STAFF REPORT
COMMUNITY DEVELOPMENT DEPARTMENT

HEARING DATE: 2/9/2021
TO: Mayor & City Council
FROM: Alan Tiefenbach, Associate Planner
208-489-0573
SUBJECT: FP-2020-0017
Lupine Cove Final Plat
LOCATION: 4000 N. McDermott Rd., in the NW ¼ of
Section 33, Township 4N., Range 1W.

Final plat consisting of 26 buildable lots, and 6 common lots on 6.89 acres of land in the R-8 zoning district developing in a single phase.

E. Final Plat Landscape Plan (date:2/19/21)

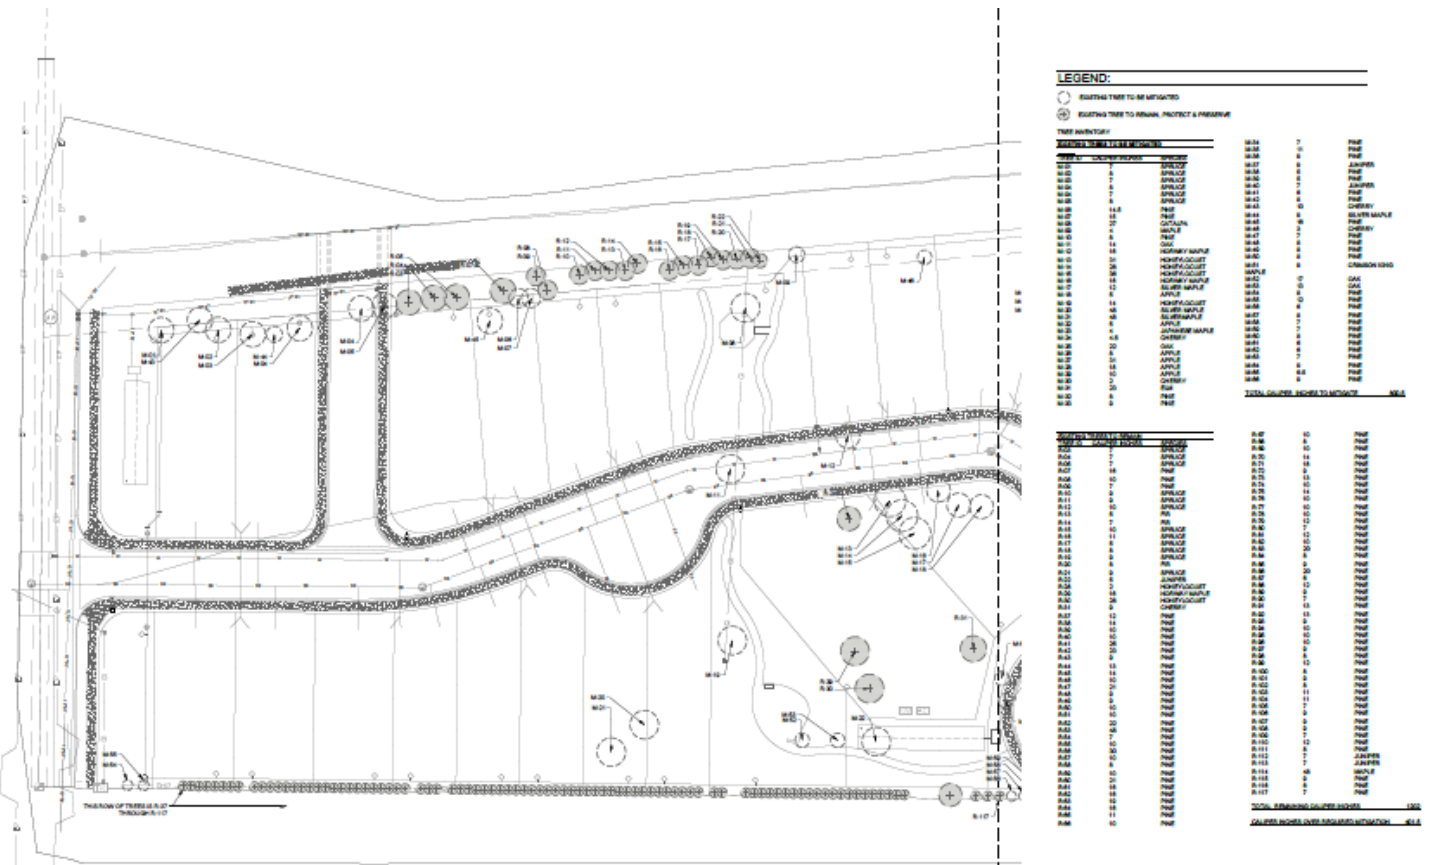
4. Prior to City Engineer signature on the final plat, the landscape plan prepared by Stack Rock Group, stamped by Willet C. Howard on February 19, 2021 shall be revised as follows:

- a. Provide details of the water feature indicated in Lot 6 of Block 2.
5. Per UDC 11-3A-6, in residential districts, irrigation easements wider than ten (10) feet shall be included in a common lot that is a minimum of twenty (20) feet wide and outside of a fenced area, unless modified by City Council at a public hearing with notice to surrounding property owners.
